AMENDMENTS TO THE DRAWINGS

FIGS. 8A through 8J are schematic cross-sectional views illustrating a twin-ONO-type SONOS memory according to a fourth embodiment of the present invention;

APPENDIX B - ANNOTATED DRAWING reflecting proposed changes to original Figs. 8I and 8J, shown in red.

FIG. 8I

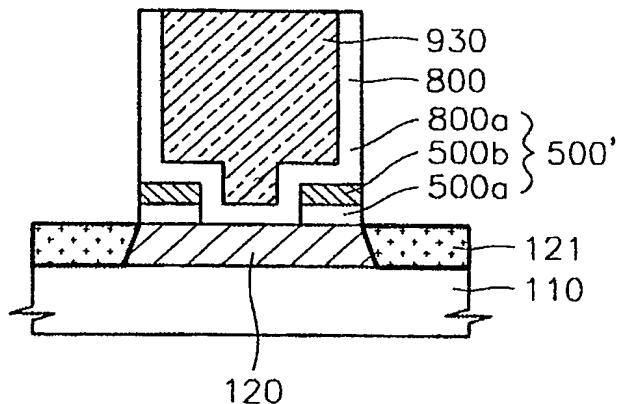
A proposed amendment to Figs. 8I and 8J is presented in the annotated drawing which appears, as APPENDIX B, on page 6. Specifically, the conductive layer 930 of Figs. 8I and 8J has been changed from a double layer to a single layer. The change is proposed to correct an obvious error as is apparent from preceding Fig. 8H and the drawing descriptions in the specification.
